**EAST GOSHEN TOWNSHIP
PLANNING COMMISSION
Meeting Agenda
Tuesday, August 22, 2023
7:00 PM**

Date: 8-17-2023
To: Planning Commission
From: Duane J. Brady Sr., East Goshen Township Zoning Officer
Re: **1010 Hershey Mill Road / Millstone Meadows
Preliminary/Final Subdivision and Land Development
Residential Open Space Development/Initial Presentation Letter**

**RE: *Millstone Meadows Subdivision
Preliminary/Final Subdivision Plan
East Goshen Township, Chester County
DHE Project No. 22-001***

Site Plan Detail, Sheet 2: Preliminary/Final Subdivision - Millstone Meadows

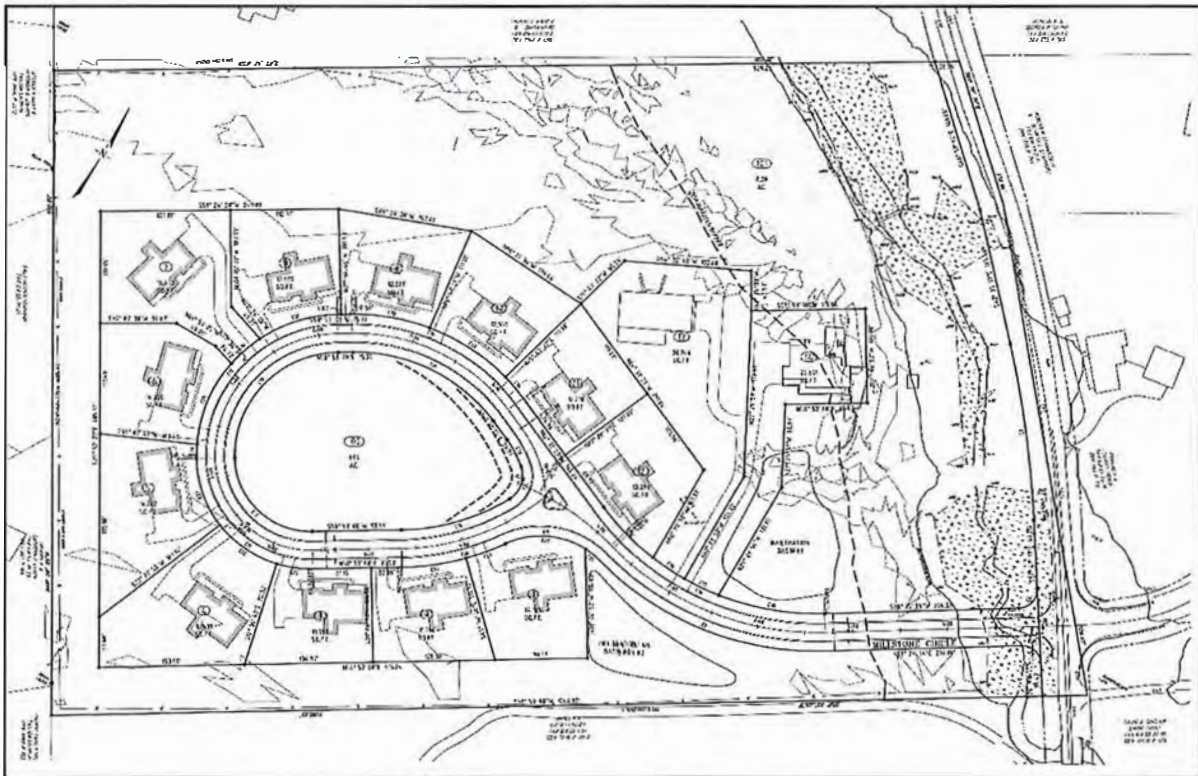
1. It is identified on Sheet 1 that the applicant obtained conditional use approval for this proposal on March 7, 2023, with 19 conditions of approval, which include the following:

- The applicant shall provide to the Township a sanitary sewer and pedestrian access easement approximately located between Lots 6 and 7, to the satisfaction of the Township (condition #5). We note that Sheet 4-Grading Plan indicates that this easement extends to the adjoining parcel to the west owned by East Goshen Township (UPI# 53-1M-21);

2. A Pipeline Awareness Study, prepared by DH Enterprises, dated January 10, 2023, was included with the plan submission. The study indicates that there are three existing natural gas pipelines approximately 450 feet to the west of the project site, and that the closest the proposed development will be located would be 500 feet from the pipelines. The study also indicates that, as required by PA Act 287, a Pennsylvania One Call has been completed, and that a “No Conflict” response has been received, a copy of which is included in the study.

5. Condition #11 of the conditional use decision indicates that the applicant shall comply with the Township's ordinances regarding sidewalks/paths, and that any waiver requests from these provisions will be considered by the Board of Supervisors during the subdivision/land development process. Additionally, condition #12 indicates that the applicant shall provide an offer of dedication of additional property along Hershey Mill Road for a potential future sidewalk or pathway. However, the site plan does not depict the location of any proposed sidewalks or future sidewalk paths. These issues should be clarified by the applicant. Sidewalks, which are an essential design element in the Suburban Landscape, would facilitate safe pedestrian access to the open space areas on the project site.

7. The site contains land within the 100 year floodplain along an unnamed tributary to Ridley Creek along the eastern portion of the project site, and the site plan indicates that the proposed road (Millstone Circle) will cross this stream. We note that the County Planning Commission does not support development in the floodplain, and the Federal Emergency Management Agency and Pennsylvania Department of Environmental Protection regulate filling or development in the floodplain. Development within a floodplain can increase the magnitude and frequency of normally minor floods, and present health and safety problems. Additionally, the applicant should be aware that an encroachment permit may be required by the Pennsylvania Department of Environmental Protection in accordance with Section 105.293 of its Rules and Regulations pertaining to stream crossings. The Township should request documentation of any required permit(s) for this project before approving the plan.

8. The project site contains existing steep slope areas (slopes 15 percent and greater). The Township should verify that the design of the slopes is consistent with all ordinance requirements related to permitted grades, the design and specifications of retaining walls and slope stabilization. Areas of steep and moderate slopes should be protected from disturbance that may cause erosion and flooding, as well as negatively impact water quality, wildlife habitat, slope stability, and scenic views.

13. Zoning Note 4 on Sheet 1 indicates that the open space areas, which shall be protected by a conservation easement, will be owned, managed and maintained by a homeowners association. Ownership, maintenance, use provisions, restrictions, and liability responsibilities associated with any commonly held amenities should be written into the Homeowners' Association (HOA) document. The HOA document should include provisions which allow the Township to: intervene and maintain common owned facilities; determine the schedule for Association formation; timing for construction of common facilities; and determine the schedule for transfer of ownership from developer to the HOA of common facilities. The HOA document should be submitted as part of the application to the municipality to be reviewed by an attorney versed in homeowners' association documents to evaluate the document for its completeness and compliance.
